SOLICITATION AMENDMENT
MODIFICATION DE L'INVITATION

Title - Sujet CABLE ASSEMBLY, SPECIAL PURPOSE	
Solicitation No. - N° de l'invitation W8482-133975/A	Amendment No. - N° modif. 005
Client Reference No. - N° de référence du client W8482-133975	Date 2013-01-10
GETS Reference No. - N° de référence de SEAG PW-\$\$HN-379-61537	
File No. - N° de dossier hn379.W8482-133975	CCC No./N° CCC - FMS No./N° VME
Solicitation Closes - L'invitation prend fin at - à 02:00 PM on - le 2013-01-25	Time Zone Fuseau horaire Eastern Daylight Saving Time EDT
F.O.B. - F.A.B. Plant-Usine: <input type="checkbox"/> Destination: <input checked="" type="checkbox"/> Other-Autre: <input type="checkbox"/>	
Address Enquiries to: - Adresser toutes questions à: Godbout, Lyne	Buyer Id - Id de l'acheteur hn379
Telephone No. - N° de téléphone (819) 956-3611 ()	FAX No. - N° de FAX (-) -
Destination - of Goods, Services, and Construction: Destination - des biens, services et construction:

Amendment 005 is raised to give additional information on the specifics of this cable assembly.

See Annex A

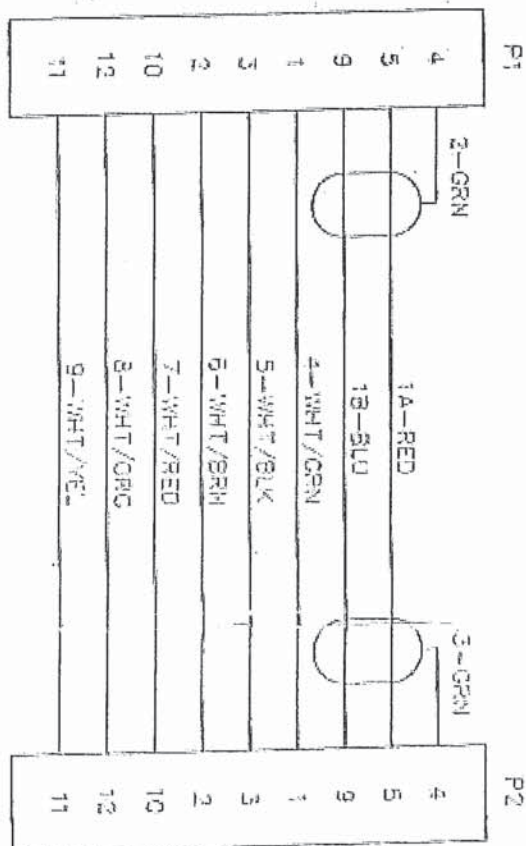
Here is the parts list going with Annex A.

1. ALL UNUSED CONTACT HOLES IN CONNECTOR P1 & P2 ARE TO BE FILLED WITH PLUGS. ITEM 7
2. CABLE SHALL BE PERMANENTLY MARKED IN APPROXIMATE POSITION SHOWN WITH .06 MIN CHARACTERS IN A CONTRASTING COLOUR. AS FOLLOWS, "36452 ASSY 8981218-1" PER SPAR ASC PCS 10:01 METHOD II.
3. SHIELD OF WIRE #1 SHALL BE TERMINATED AT P1-4 & P2-4 USING ITEM 5 & 6 INSIDE ITEM 3.
4. TERMINATE ITEM 4 CABLE OUTER SHIELD USING ITEM 3, CLOSE TO EXPOSED END.
5. SERVICE WIRE LOOP SHALL BE MIN 1.50 IN LENGTH.
